Before the Common Council of the City of South Bend

RE: Application for Certificate of  
Appropriateness, No. 2017-0602A

**CERTIFICATION OF DOCUMENTS OF RECORD FROM HISTORIC  
PRESERVATION COMMISSION**

Site Plan

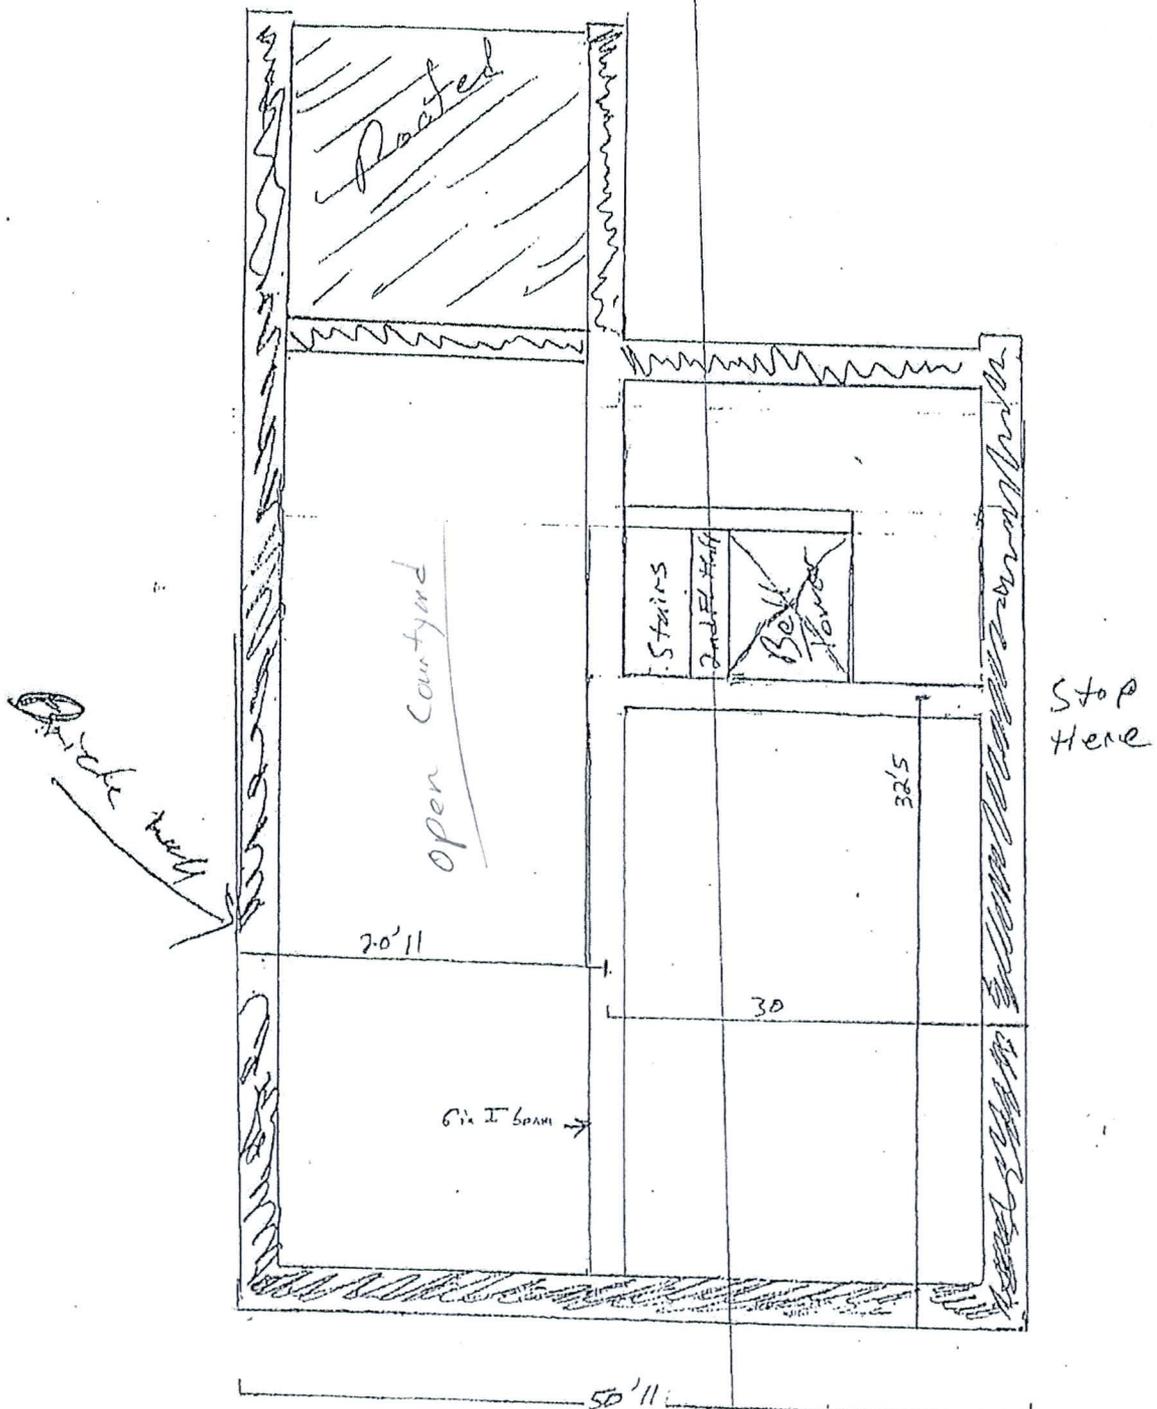
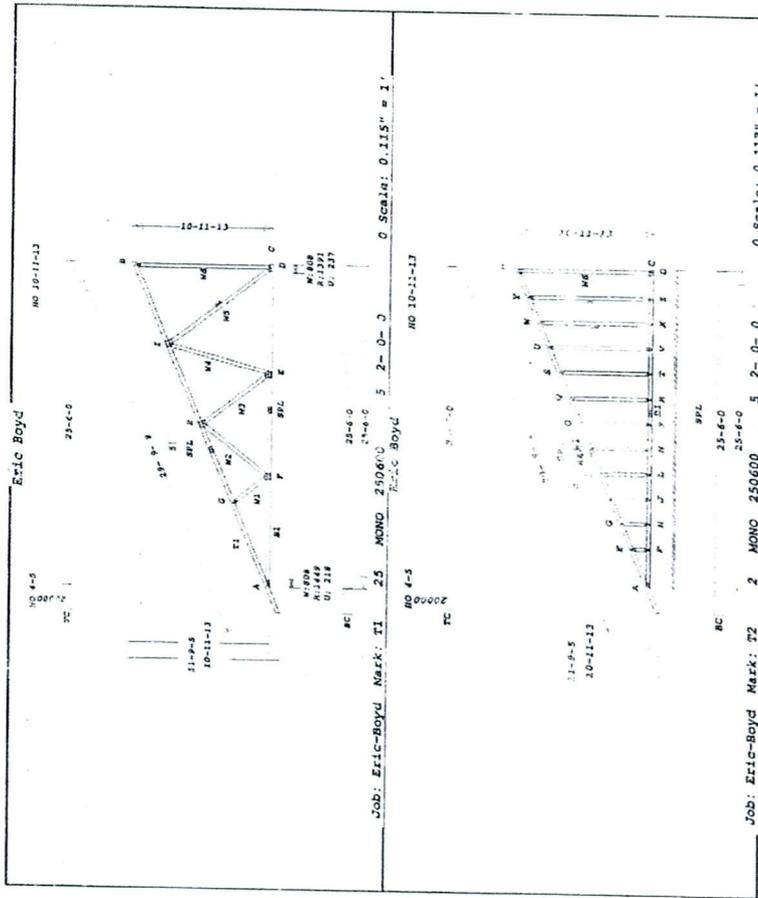
**Commissioner Hertel (AYE):** *Under Standards and Guidelines Group B Section C this would alter and modify the structure and change it greatly by adding this type of roof; plus, we are lacking information on the materials to be used for completion of the roof.*

**Commissioner Buccellato (AYE):** *The design simply does not meet the existing character of the structure.*

**Commissioner Anderson (AYE):** *It would alter the façade, architectural integrity, and its style, which are some of the most important things we have to make a decision on as a Commission.*

**Commissioner Gordon (AYE):** *It is not in keeping with the guidelines for this building, does not keep the historical character or look of the building, and we are missing some information of how that roof would be covered.*

**Commissioner Molnar (AYE):** *The design is too far outside of the mandated Standards and Guidelines which the Commission, by law, must follow. The roof would be prominent in display in the front of the structure, as opposed to the rear. I would be in favor of looking at something with a lower pitch, not necessarily a flat roof.*

Although the historic preservation commission did not find your proposed project to be architecturally appropriate and did not believe that the denial would be a detriment to the public or cause hardship, the commission and staff believe it is important to save this building. Accordingly, staff believes that it is important to revisit design alternatives that were mentioned during deliberation. As a compromise to in-kind flat roof replacement, members of the Commission suggested a deviation for a hip roof (originating from the north facade parapet and having a downward slope to the south). This would make a drastic improvement over the current plan by not detracting from key architectural features, still be compatible with water management/drainage proposals and allow for building material from the current structure to be reused. The latter representing a significant cost savings for you.

HPC Staff encourages you to thoughtfully consider this alternative design concept and welcomes the opportunity to consult on a new application. Thank you for your continued stewardship of this local landmark.

Layout for Truss Design

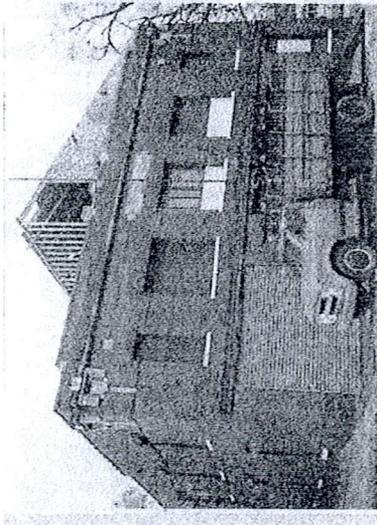
4. Framed mono-sloped roof at North West: A ledger (2) 2x8s should be added to the east stud wall, raised up to be snug under the birdsmouth cut rafters. Hurricane clips should be added- rafter to ledger. 16d nails at 8" oc – ledger to wall top plate and (2) 16d nails to each stud below. Note that the 1<sup>st</sup> 2x8 should be nailed as above & the 2<sup>nd</sup> 2x8 nailed to the 1<sup>st</sup> – 2 rows 16d nails at 12" oc. Add blocking 2' oc at north end bay at rafters to ext. framed wall. Attach wall to masonry at top of existing parapet.
